TECHNICAL INFORMATION

SUBJECT: Pipe on ECHO PB-2520, PB-2620, shindaiwa EB252 and EB262

Number: Y2020-677(1/2)
Issued: Jan. 31, 2020

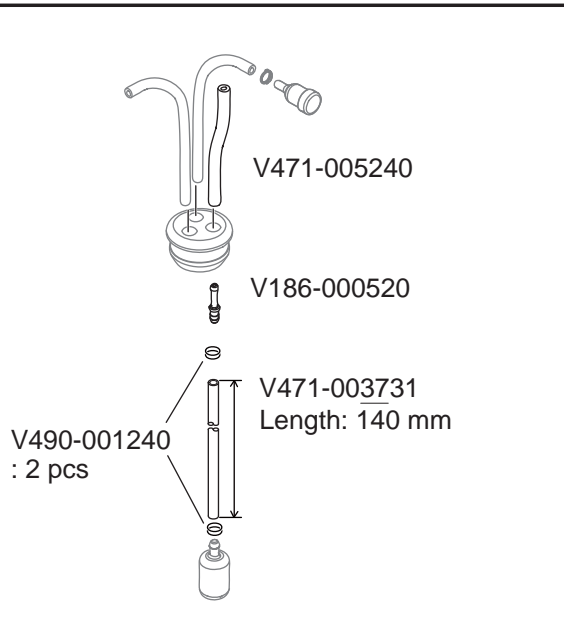
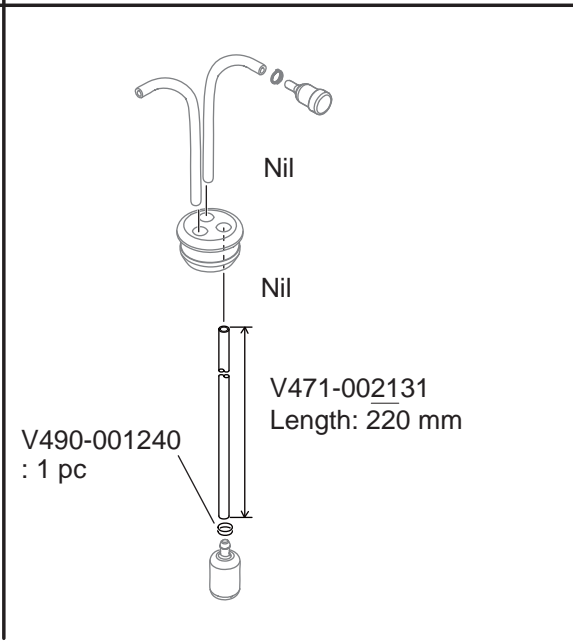
Parts unification		
PB-2520 (30)	Serial Number 30001100 and before	Serial Number 30001101 and after
PB-2520 (38)	Serial Number 38002306 and before	Serial Number 38002307 and after
EB252 (38)	Serial Number 38003980 and before	Serial Number 38003981 and after
Fuel pipe Joint pipe Fuel pipe Clip	 <p>V471-005240</p> <p>V186-000520</p> <p>V471-003731 Length: 140 mm</p> <p>V490-001240 : 2 pcs</p>	 <p>Nil</p> <p>Nil</p> <p>V471-002131 Length: 220 mm</p> <p>V490-001240 : 1 pc</p>
Pipe V471-002131 can be used on the unit before this change.

NOTE: Distance (a) of fuel pipe is the same.

TECHNICAL INFORMATION Number: Y2020-677(2/2)

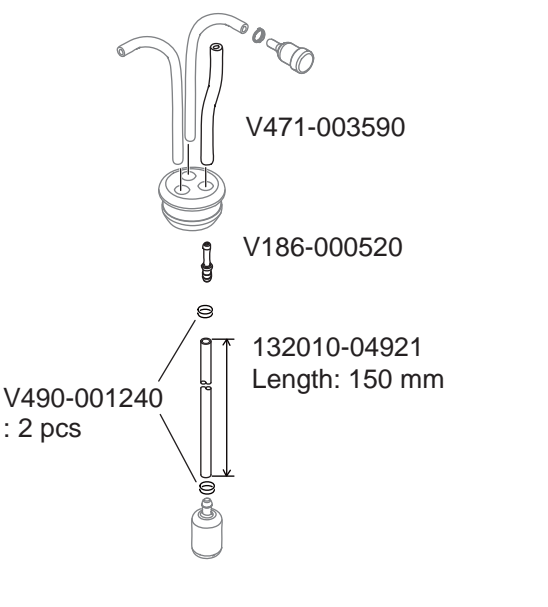
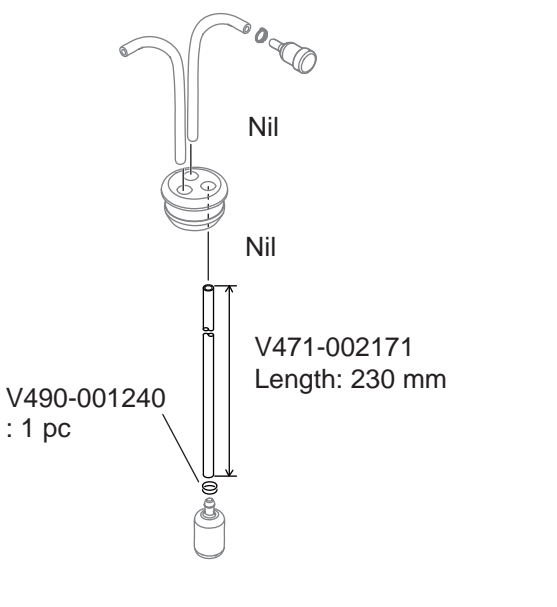
PB-2620(38)	Serial Number 38005562 and before	Serial Number 38005563 and after
EB262 (38)	Serial Number 38002052 and before	Serial Number 38002053 and after
<p>Fuel pipe</p> <p>Joint pipe</p> <p>Fuel pipe</p> <p>Clip</p>	 <p>V471-003590</p> <p>V186-000520</p> <p>132010-04921 Length: 150 mm</p> <p>V490-001240 : 2 pcs</p>	 <p>Nil</p> <p>Nil</p> <p>V471-002171 Length: 230 mm</p> <p>V490-001240 : 1 pc</p>
<p>Pipe V471-002171 can be used on the unit before this change.</p>

NOTE: Distance (a) of fuel pipe is the same.
